Application for Amendment of Plan Under Section 12A of the Town Planning Ordinance (Cap. 131) to Rezone the Application Site from “Green Belt” and Area shown as ‘Road’ to “Residential (Group C)5” for Proposed Residential Development at Various Lots in D.D. 210 and Adjoining Government Land, Pak Wai, Sai Kung (Planning Application No. Y/SK-HC/8)

Submission of Further Information – Responses to Departmental Comments

Responses-to-Comments Table

DRAWING TITLE **PROPOSED CAUTIONARY CROSSING AT HING KENG SHEK ROAD**

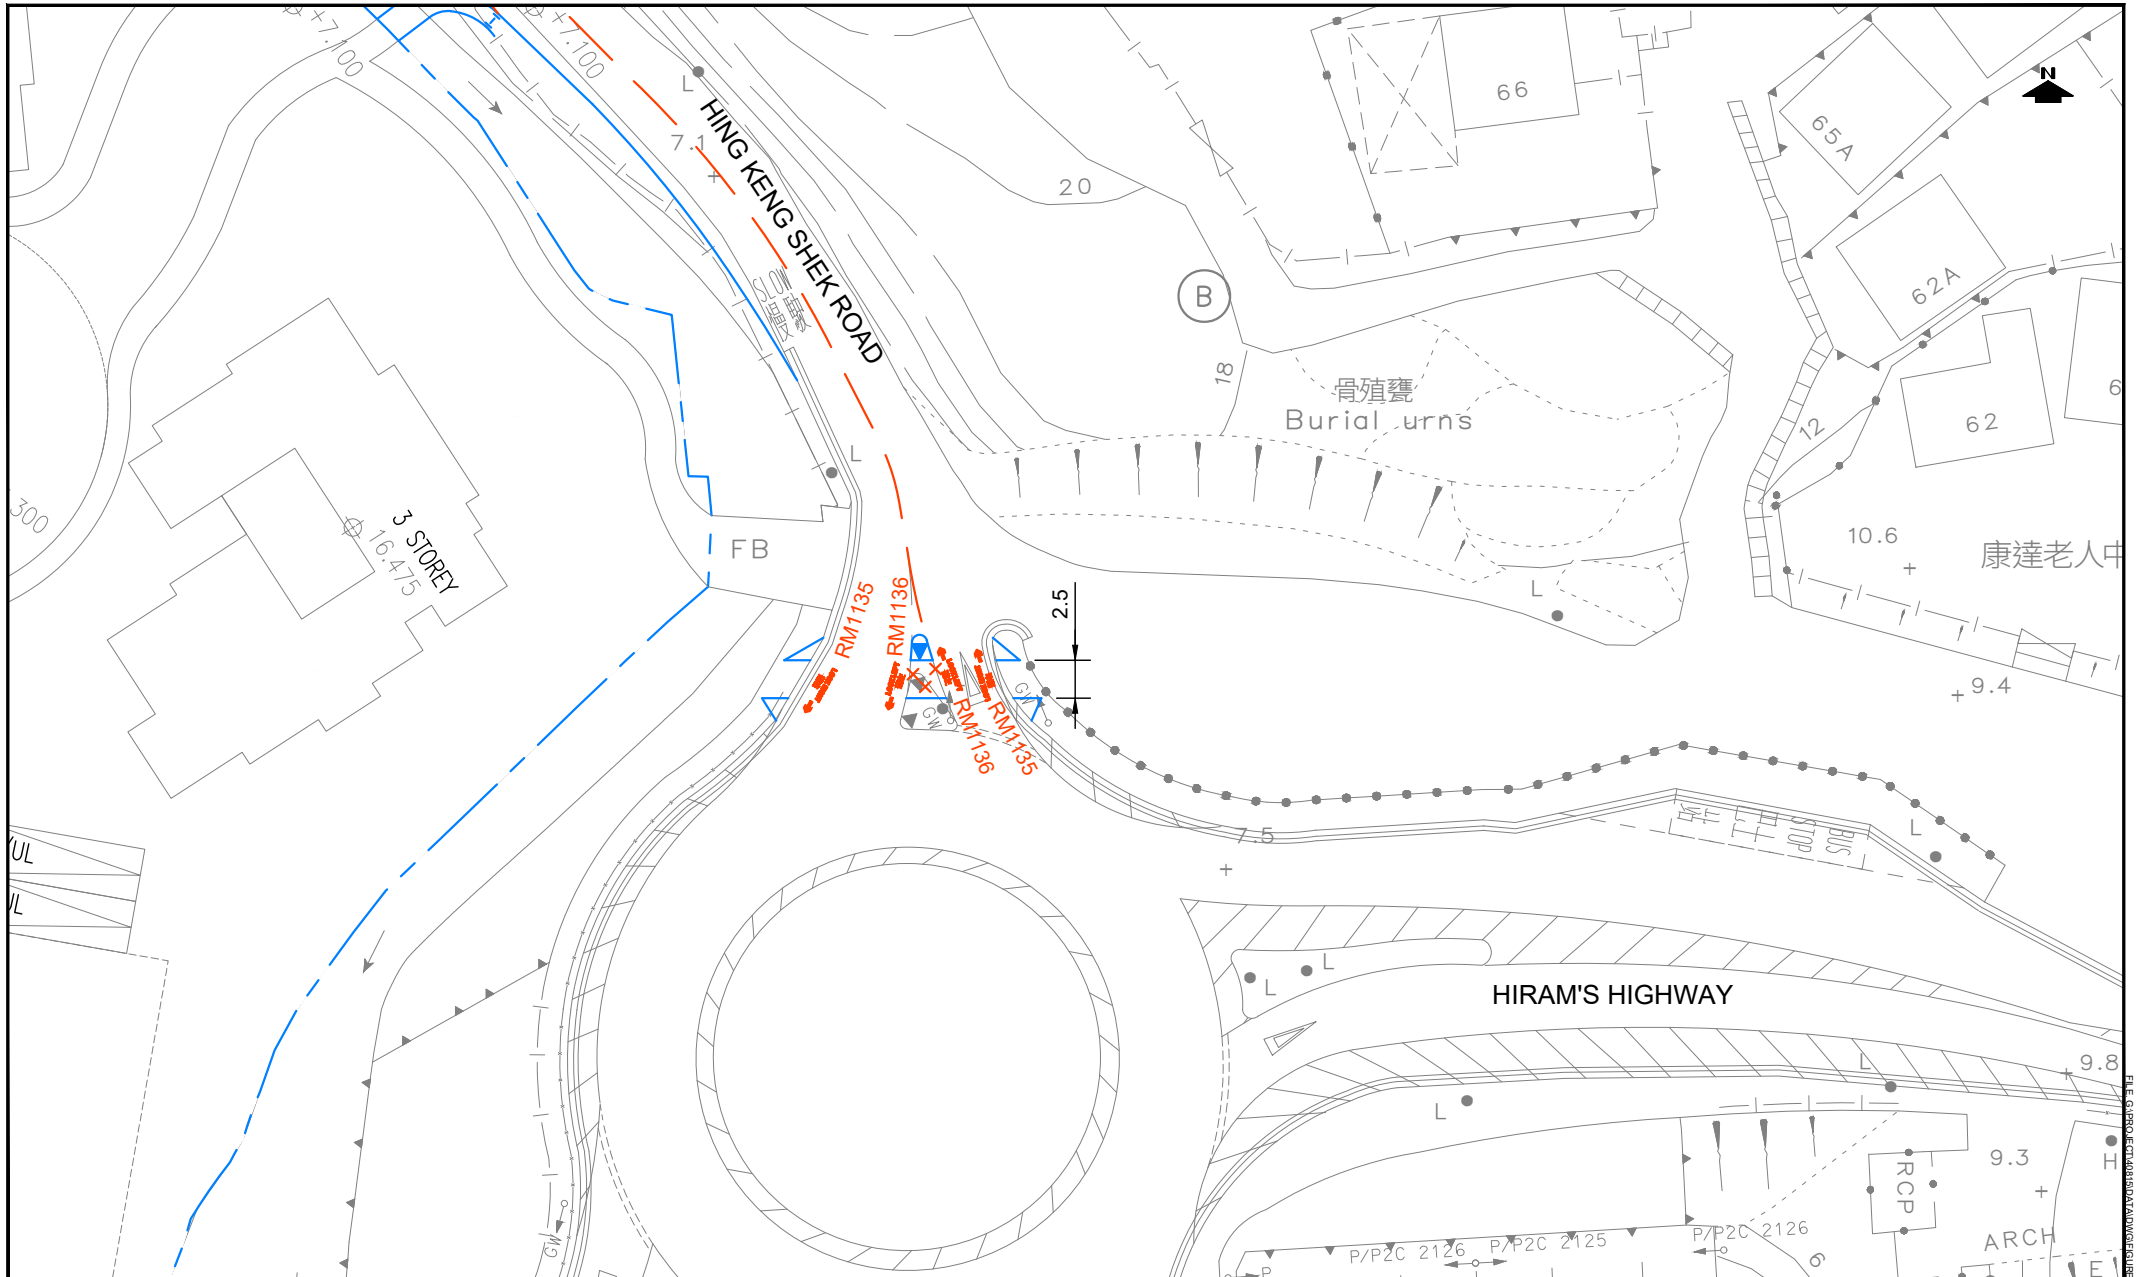
No.	Comments	Responses
	<p>4. Re. Section 4.2.1, the latest Annual Traffic Census Reports shall be adopted.</p> <p>5. Re. Section 5.1, please review the pedestrian access arrangement across the Pak Wai roundabout.</p>	<p>Noted. The latest AADT figures are adopted accordingly. Please refer to Section 4.2.1 of the Updated TIA for details.</p> <p>Noted. A cautionary crossing is proposed to facilitate pedestrians across the Pak Wai roundabout. Please refer to Section 5.3 and Figure 5.5 for details.</p>
